PLAN COMMISSION

DATE: MONDAY, JUNE 8, 2026

To: Village of Cambridge Plan Commission
From: Steve Tremlett, AICP, Zoning Administrator
Subject: 708 Katie Court – Site Plan Review Application
Date: June 4th, 2026

Re: Proposed Commercial Building, Business Office Condominiums
708 Katie Court, Cambridge WI 53523
Preliminary Site Plan Review

**SITE PLAN
 FOR
 KJELL KAASHAGEN
 A NEW COMMERCIAL BUILDING**

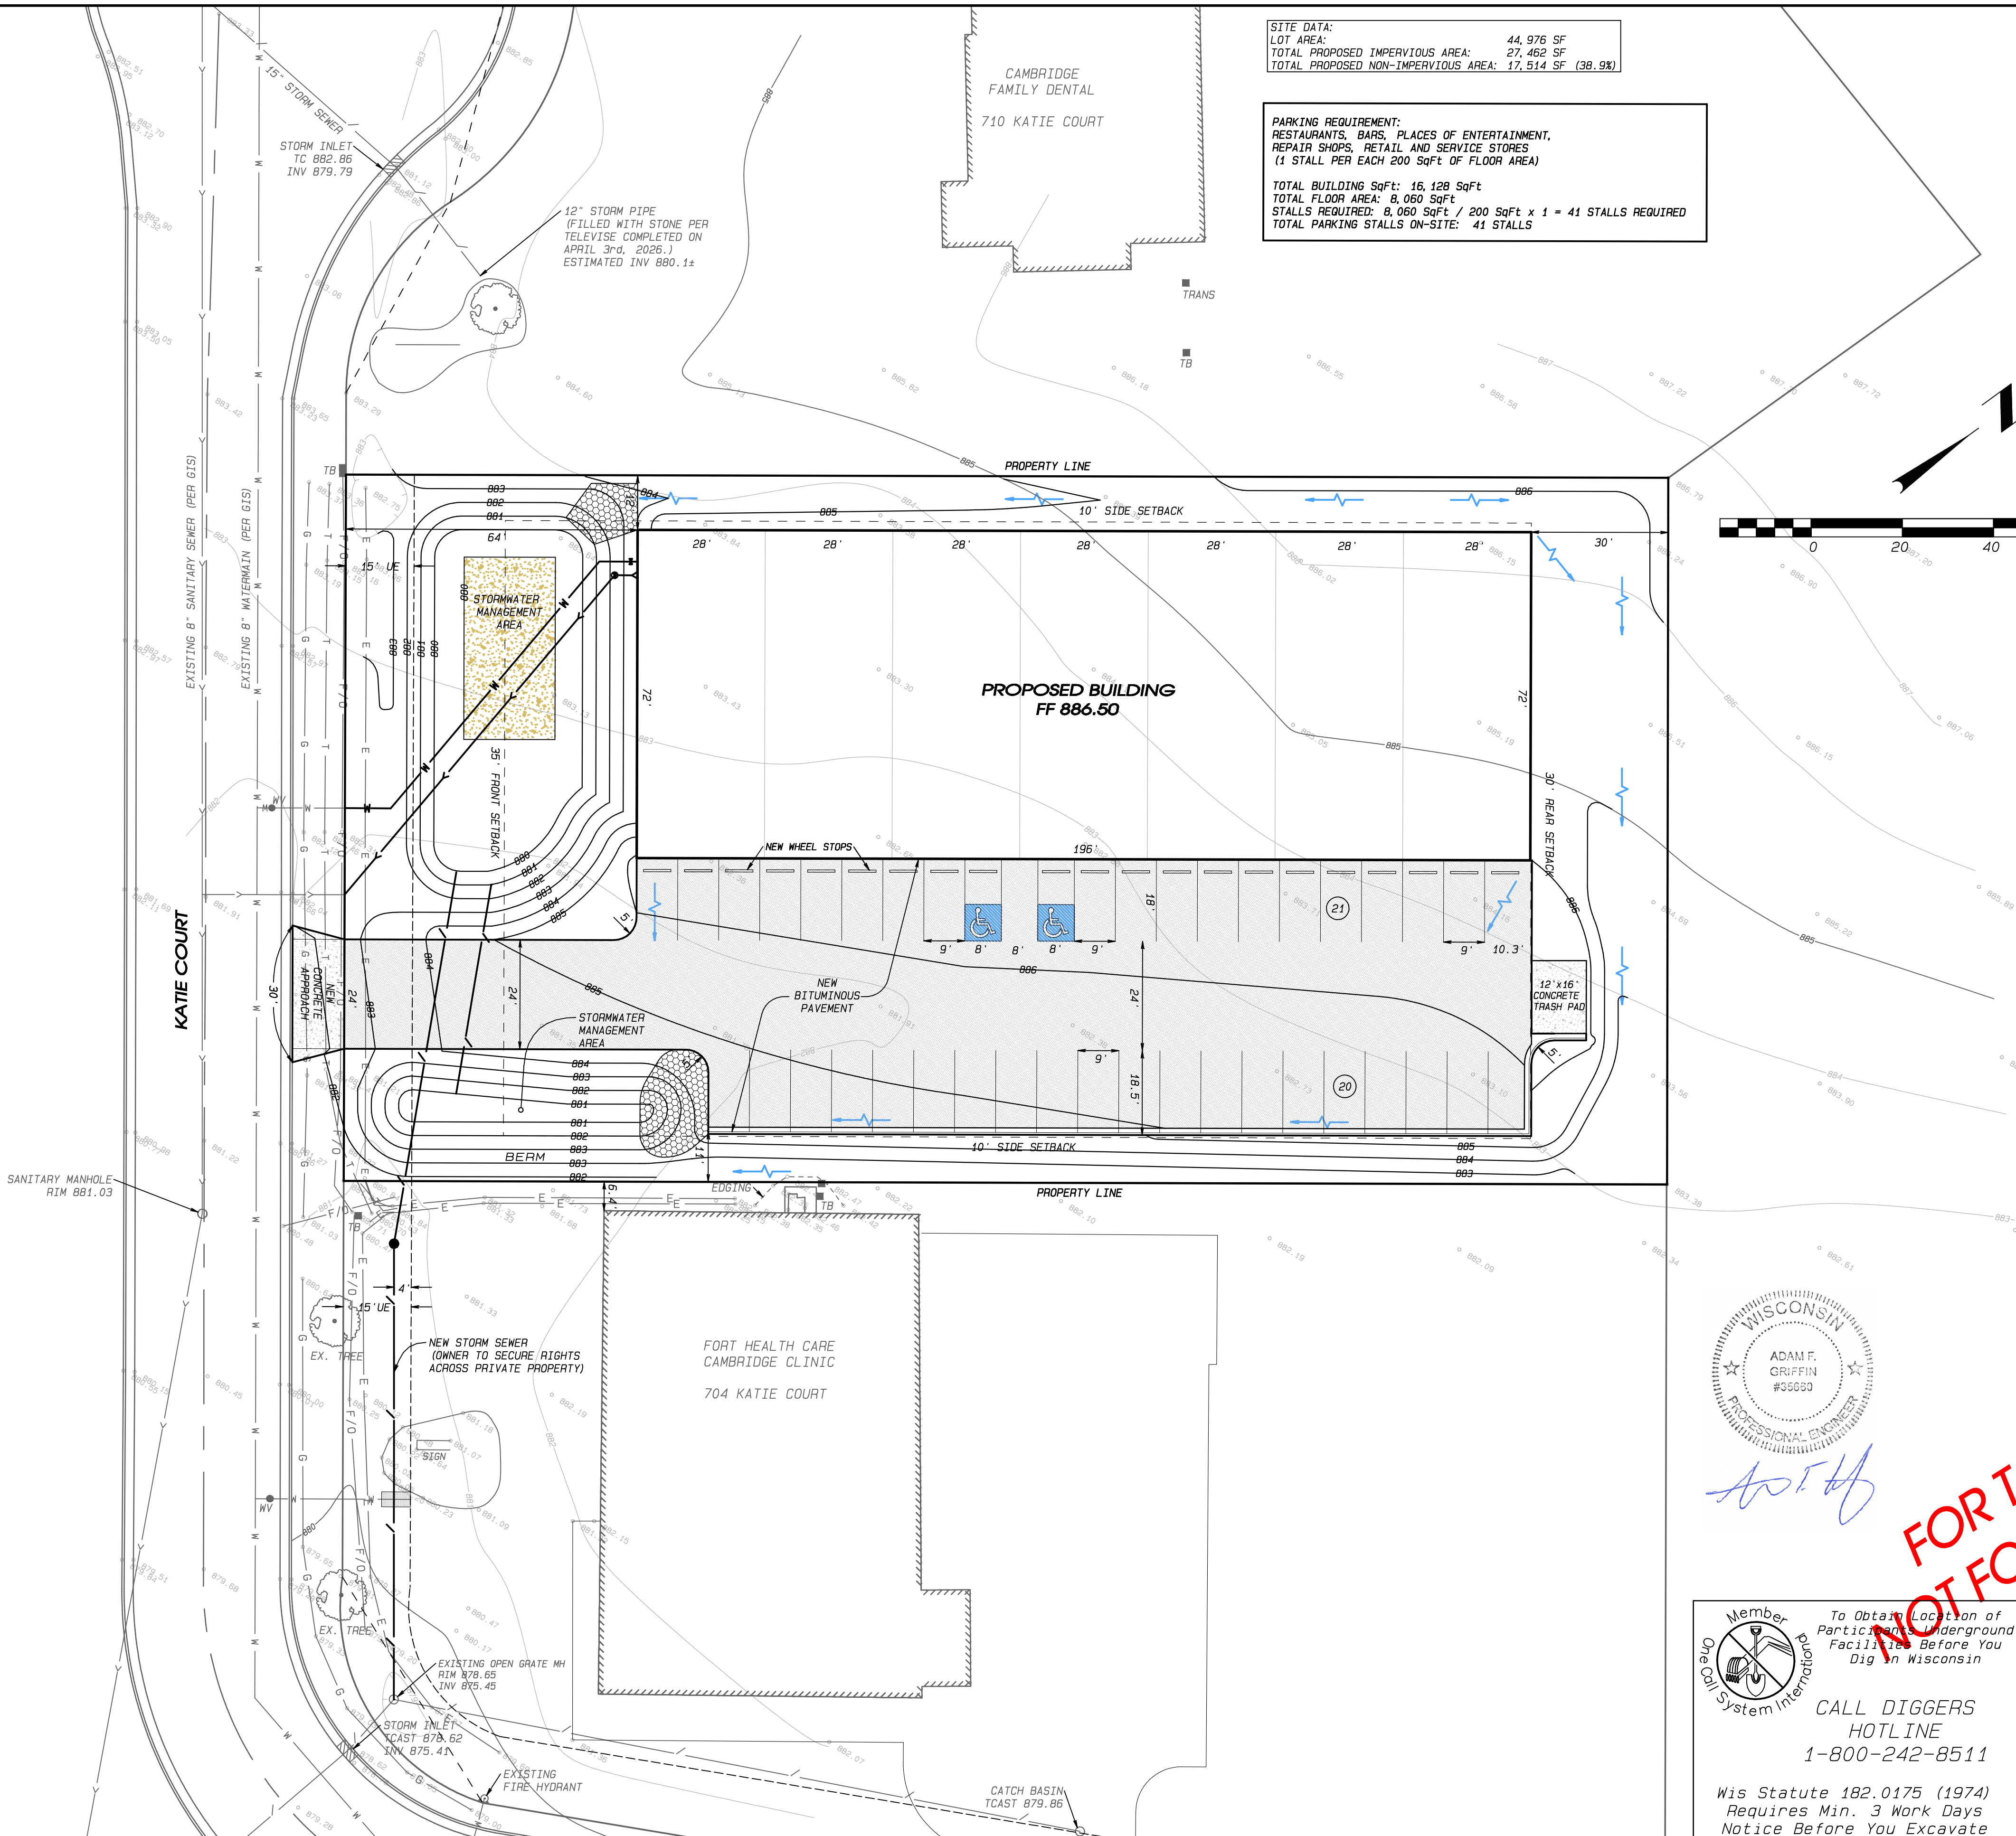
Per Mixed Business zoning district bulk standards, lots shall not exceed 40% of lot coverage. While the plans state 38.9% lot coverage (on dimensional plan), MSA calculated 61.1%. This will require a reduction in impervious area (i.e., building and/or pavement) by over 20% of the site. The alternative is the applicant can consider submitting a zoning amendment that would be a global change to the zoning district bulk standards.

- ✗ The furthest east spaces (shown in red boxes on the right) do not allow backing maneuverability. There should be at least 3 feet of pavement extended in the drive aisle prior to the trash concrete pad.
- ✗ ADA access route does not meet standards, allowing safe access to all units. The recommended design is to have at least a 4-foot concrete walkway in front of parking stalls that front the building (concrete walk can be at grade of asphalt parking area). Also, the accessible aisle should be marked appropriately in plans.

3. Section 17.32.040 – Lot, yard and building requirements. Percentage of Lot Coverage stated is a maximum of 40% for the B-H Highway Business District. The plan shows the percentage of hard cover at 61.1% exceeding the 40%.

1. Applicant shall revise the site plan and corresponding documents to resolve the issues outlined below and submit to zoning administrator for approval of meeting compliance.
 - a) Submit a landscaping plan, lighting plan (with photometrics), and signage plan for any group/site sign in accordance with village codes and CUP conditions.
 - b) Achieve compliance with the 40% maximum lot coverage standard.
 - c) Resolve the parking lot design issues noted in this staff report and the engineers review memo.
 - d) Resolve other issues identified in the engineers review memo.
2. Applicant shall obtain Dane County stormwater approval and submit confirmation to the Village prior to building permit issuance.
3. Applicant shall provide all outstanding information and design improvements to the satisfaction of the Village Engineer prior to building permit issuance.

WATER SERVICE DETAIL

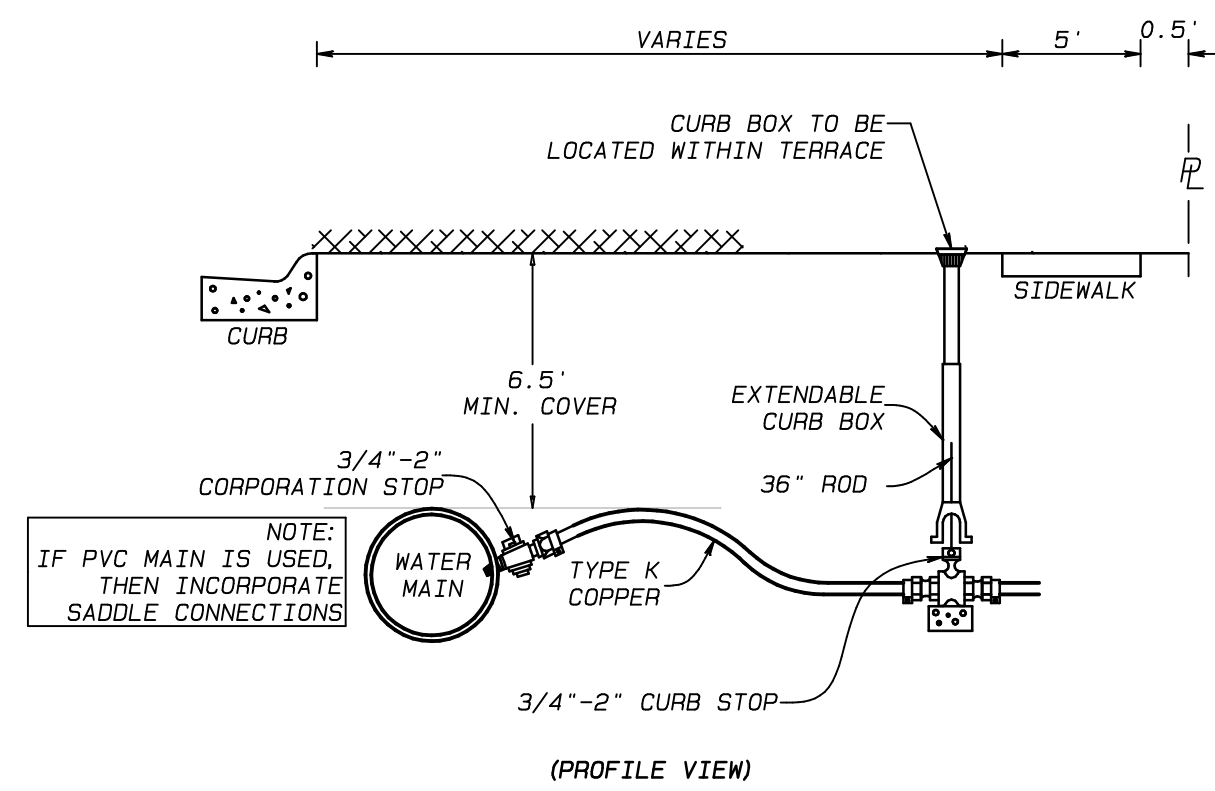
21. A 6" service has been stubbed to the property line. Shut off valve is in the street in front of the parcel. Provide detail on how and where you will transition to smaller water service.
22. Revise detail on sheet 3 of 6 to match the site plan sizes.
23. Provide a profile for the water service from the shutoff valve in the street to the building.
24. Will this building include fire sprinklers? If so, provide calculations. If not, provide WSFU calculations to properly size the remaining portion of the water service for the intended uses.
